**PRE-APPLICATION CONFERENCE NOTES**  
**Heritage Center Building B (File # 2021-003-PAC)**

Meeting Date	Friday, February 12, 2021 at 10:00 a.m.
Date of Issue	Friday, February 18, 2021

# Attachment A

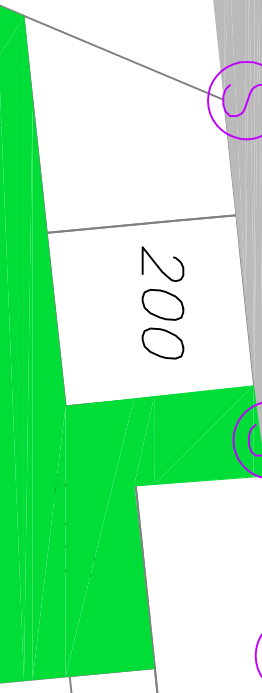
- To be consistent with the type of light of Cedar Avenue and East 5<sup>th</sup> Street, New lights may have to be added as necessary to meet the Engineering Standards. New streetlights may be needed to accommodate existing lighting on Cedar Avenue and meet the current lighting standards in the Engineering Standards.
- A Photometric analysis along 5<sup>th</sup> Street frontage improvements and the intersection of Cedar Avenue and 5<sup>th</sup> Street needs to be submitted to verify compliance with the Engineering Standards.

- Street lighting on local streets shall be Acorn full cutoff single fixture on a black decorative fiberglass pole per the Engineering Standards. To be consistent with the type of light of Cedar Avenue and East 5th Street, new cobra head lights may need to be used if the photometric plan results in more lighting that needs to be placed.

- Submit a Photometric analysis along with the streetlight design to verify compliance with the Engineering Standards.
